Access Compliance Report Public Rights-of-Way (Curb Ramps)

Main Street: EL_CAMINO_LN Cross Street: NEWPORT_AVE Location: SE

ADA ID: RPRK211007132439 Ramp Type: Type 1 - Perpendicular Diagonal Initial Pass/Fail: Fail Overall Compliance: No Severity Score: 15

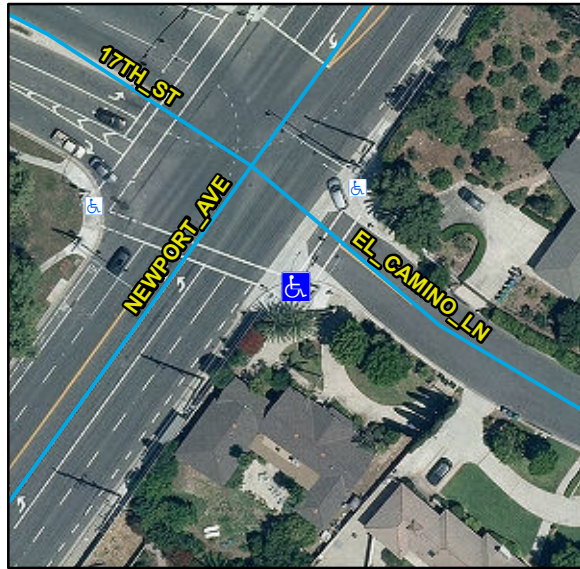
R304.2.2, R204.3, STD 1115

Remove & Replace Curb Ramp With Two New Directional Ramps or Equivalent.
